SERVICE BULLETIN CHANGE NOTICE

S.B. No. A320-21-1013 REV.

MOD. No. 21110/P1441

TITLE : AIR CONDITIONING - COCKPIT VENTILATION INSTALL A GRILL IN AIRDUCT.

Installation of Grill  
Figure 1

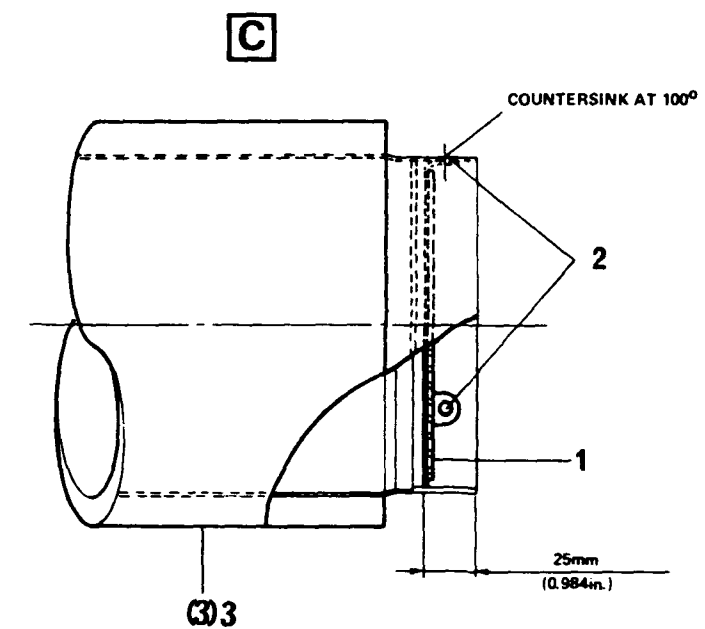
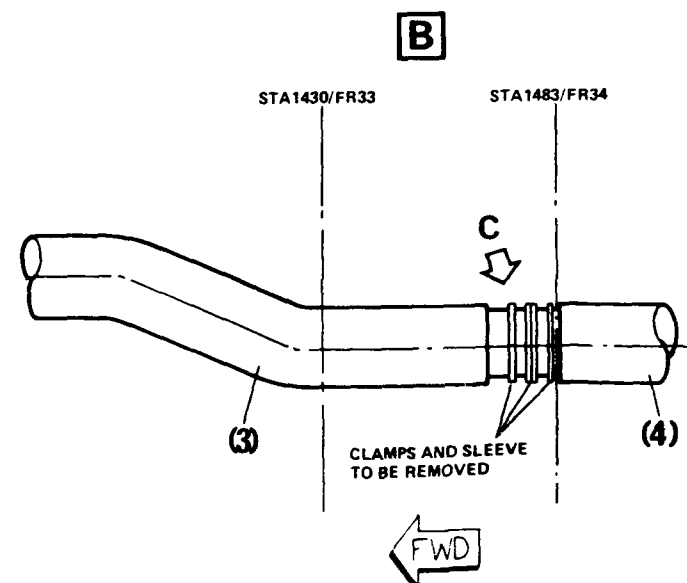
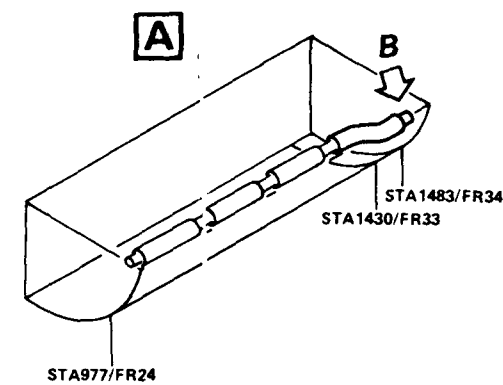
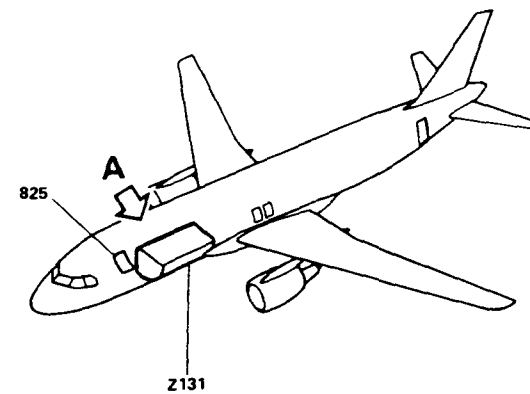
In forward cargo compartment, in zone 131 between STA1430/FR33 and STA1483/FR34, installation of a grill at end of flight compartment air conditioning duct.

(1) Remove clamps and flexible sleeves between ducts Items (3) and (4).

(2) Install grill on duct Item (3).

1 grill D2121113100000 Item 1

Matchdrill to 2.4 mm (0.094 in.) dia., countersink and attach with :

3 rivets ASNA2051DCJ02412 Item 2.

- (3) On ducts Items (3) and (4), install clamps and flexible sleeves retained during removal.
- (4) Part Number of Modified Item  
D2121031500000 becomes D2121031500200.
- (5) Install sidewall Panels 131MW, 131PW (Ref. AMM 06-41-53).
